Panel Report

Yarra Planning Scheme Amendment C231

Queens Parade Built Form Review

31 October 2019

Figure 5: Map of Precinct 3

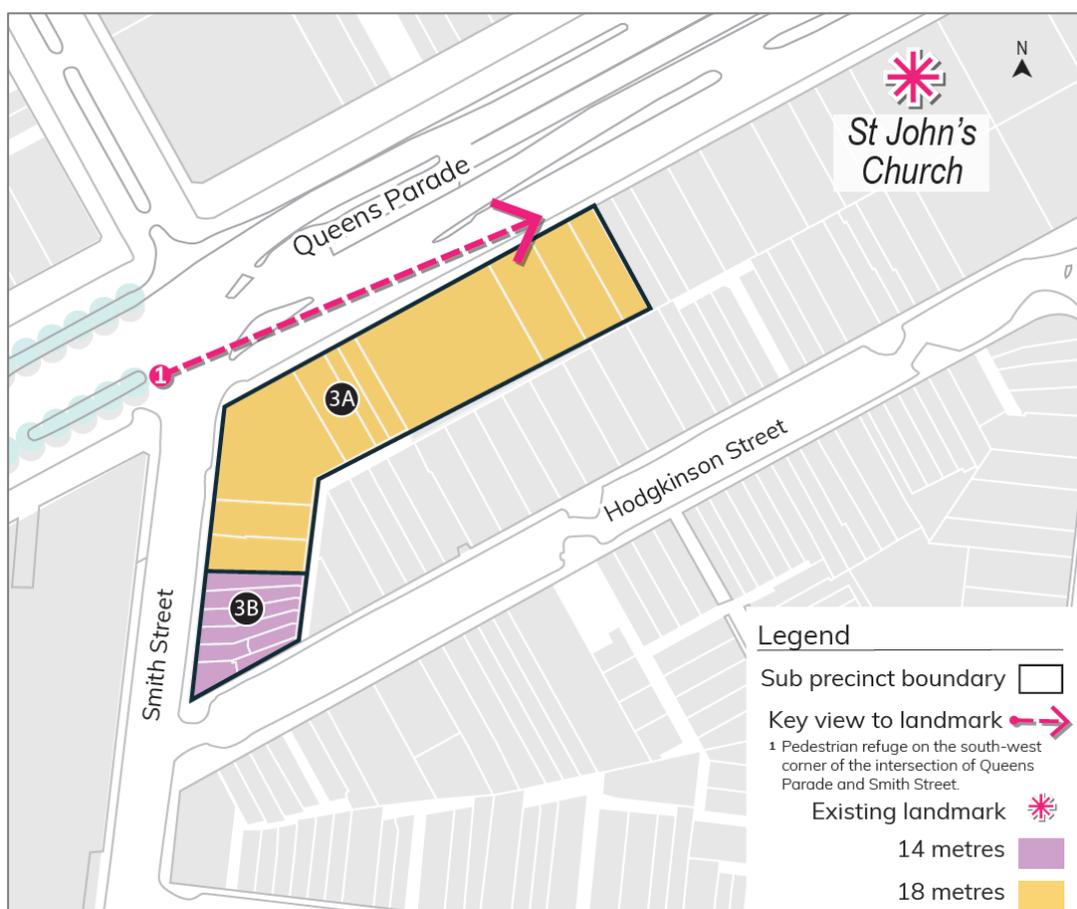
Mr Parsons questioned the value of the mandatory requirement to require clear sky to be retained around the spire and belfry of St Johns Church when viewed from the key viewpoint identified in Figure 5. He opined that while the viewpoint in the preferred DDO16 allowed a view of the spire, it was not helpful in assessing the impact of different heights. He observed this view was not noticeably impacted by development at heights greater than the proposed mandatory maximum height of 18 metres.

The Panel considers this confusion was partly due to modelling of the view that did not accurately reflect the conditions (e.g. Figure 7.9 in Mr Parsons evidence statement). The modelling did not include any trees, street infrastructure or street furniture that in the actual view, impact or partly obscure the view. To appreciate all components of that view, a viewer standing in the nominated location would have to make several observations from several slightly different locations.

Map 5 - Precinct 5

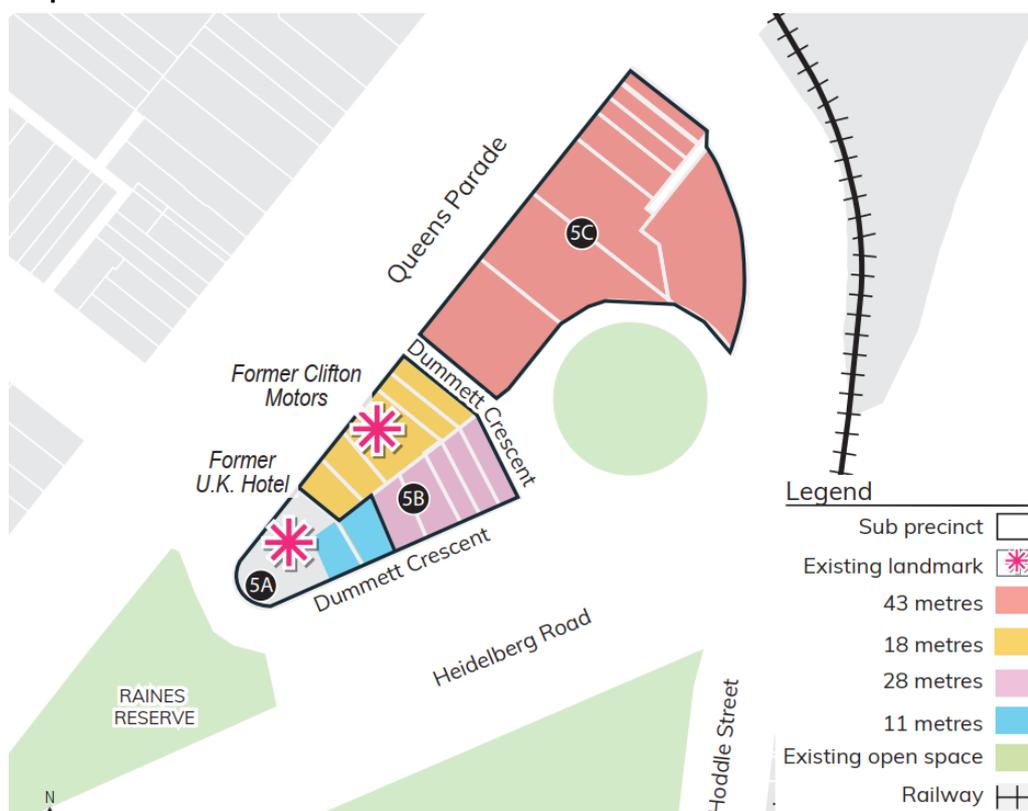
Include the viewpoints
